Power Grid Company of Bangladesh

Capacity Enhancement of Existing Grid Substations and Transmission Lines Project Design, Supply, Erection, Testing & Commissioning of capacity enhancement and Capacitor Bank installation with associated switchgear in existing grid substation (Package-2, Lot-1)

Clarification No.02

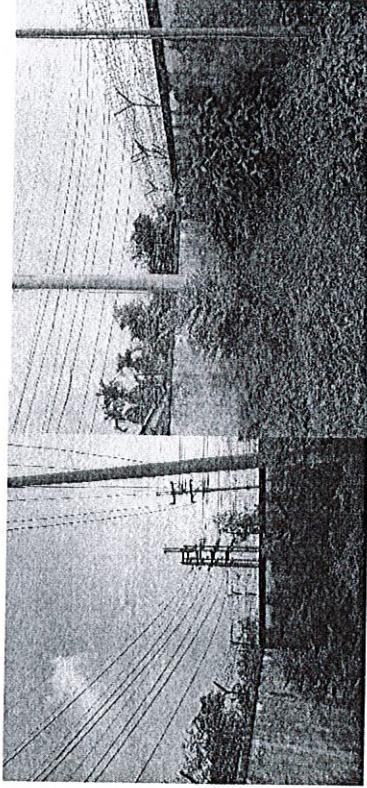
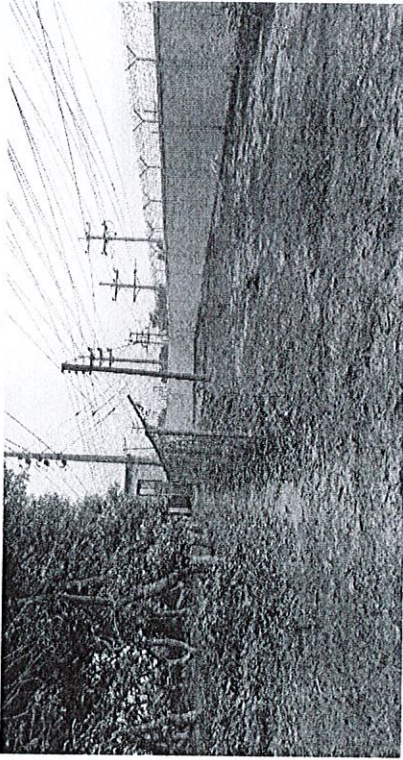
As per actual site condition, we understand through the existing approach road that, mobilization of 450MVA transformer is not possible. In this circumstance, kindly give us proposed plan.

6.	<u>Section III: 230/132/33kV transformer replacement at Tongi 230/132/33kV AIS Substation</u>	Please follow the bidding documents.	N
